ICBM
FAN HARNESS
A4WL NEUROLAB

CODE IDENT NO. 21356 | SIZE D | DWG NO. SEG46113972
SCALE NONE | EAS J104 | SHEET 1 OF 1

DRAWING CHANGE NOTICE

DCN NUMBER						
DRAWING NO. SED46113972	REV NC	SEQ.# 01	REASON FOR CHANGE: ENGINEERING CHANGE.	ORIGINATOR C. NUNEZ	DATE 3/17/99	QE M. IWASA	DATE 4/1/99
DRAWING TITLE: ICBM FAN HARNESS A4WL NEUROLAB				ENG H. CHARLES	3/17/99	MATL F. MONTELEONE	3/25/99
				CH H. LUDL	3/16/99	STRESS D. VAN	3/31/99
PROJECT: B104				APP C. CHAMBELLAN	4/5/99		
				AUTH		FINAL APP

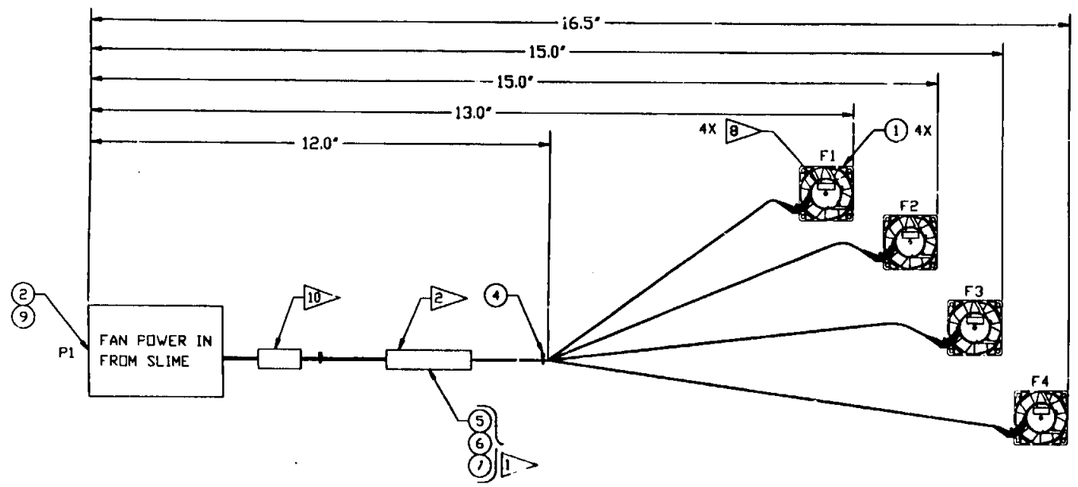
LOCATION IS AT C7.
ADDED A TOLERANCE TO THE 12.0" DIMENSION.

WAS:	IS:
12.0"	$12.0''^{+0}_{-3}$
